Approval of an Amendment for Contract 6881 with Michels Trenchless, Inc. for Additional Scope for Early Work on the Tri-City Water Resources Recovery Facility Outfall Project. Amendment value is \$453,536.60, contract value is increased to \$2,158,083.60. Funding through Water Environment Services Construction Fund. No County General Funds are involved.

**AMENDMENT #1
TO THE CONTRACT DOCUMENTS WITH MICHELS TRENCHLESS, INC. FOR TRI-CITY
WRRF OUTFALL PROJECT P632241
Contract #6881**

Supplemental Geotechnical Investigation Work Plan

Tri-Cities Water Resource Recovery Facility (WRRF) Outfall

Figure 1 – Proposed Plan of Supplemental Investigation (1 of 2)

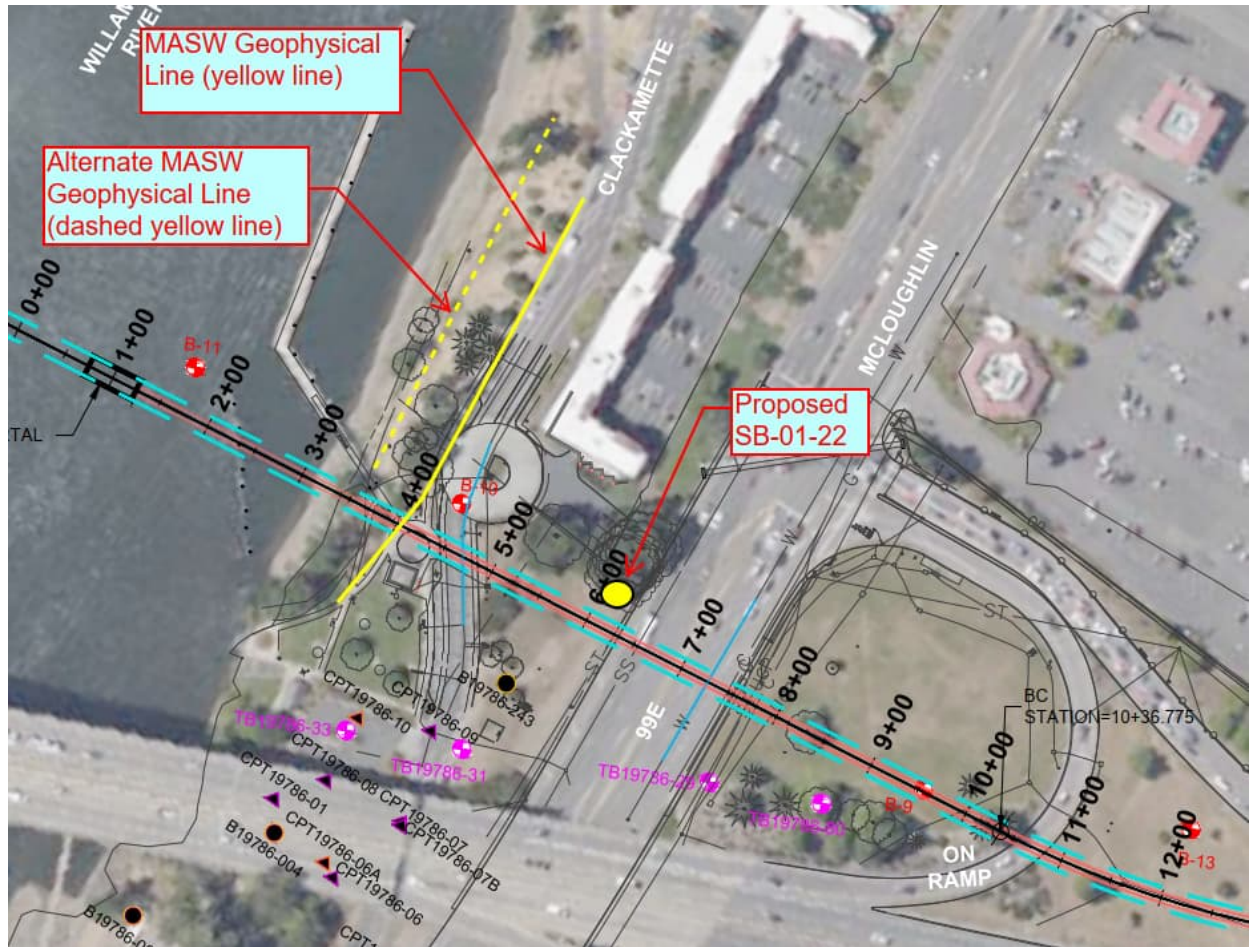
The proposed geotechnical borings are summarized in **Table 1** below. A plan of the proposed boring locations is provided in **Figure 1** and **Figure 2**. The purposes of the borings are to address items listed in the “background” section of this proposal.

A plan of the proposed geophysical survey array at the at the outfall location near the bank of the Willamette River is provided in **Figure 1**. The geophysical array will be performed using the multi-channel analysis of surface wave (MASW) method to produce a one-dimensional (1D) profile of shear wave velocity (V_s) versus depth. A minimum 350-foot-long array is preferred to obtain the required survey depth and resolution.

Figure 2 – Proposed Plan of Supplemental Investigation (2 of 2)

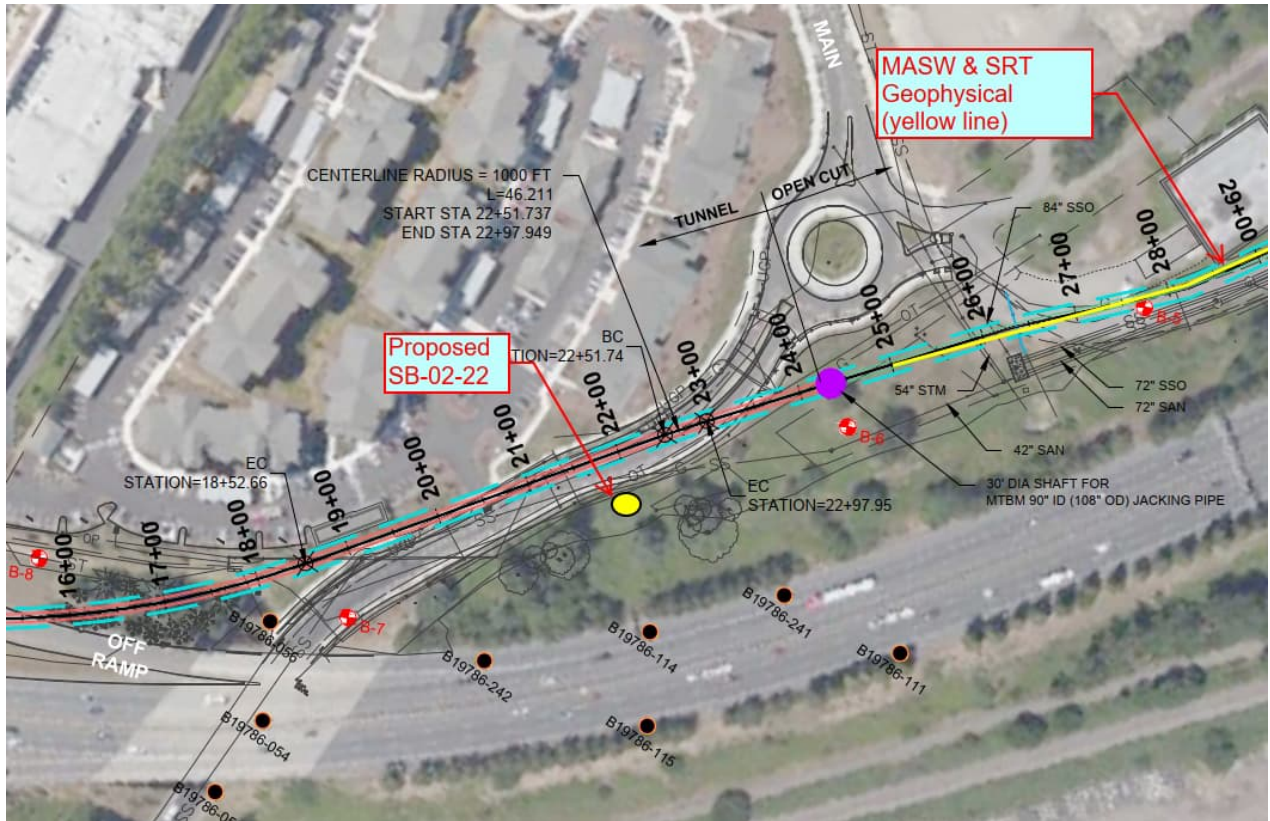
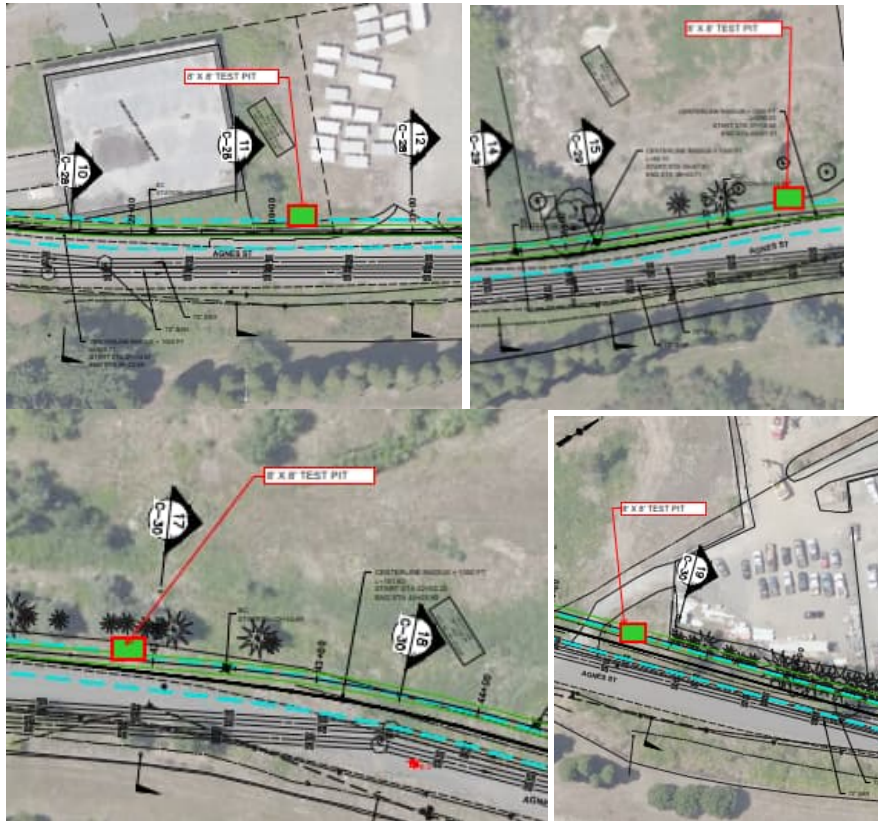
A plan of the proposed geophysical survey array at the Unpermitted Rossman Landfill is provided in **Figure 2** and **Figure 3**. The geophysical investigation will be performed using two different methods as follows:
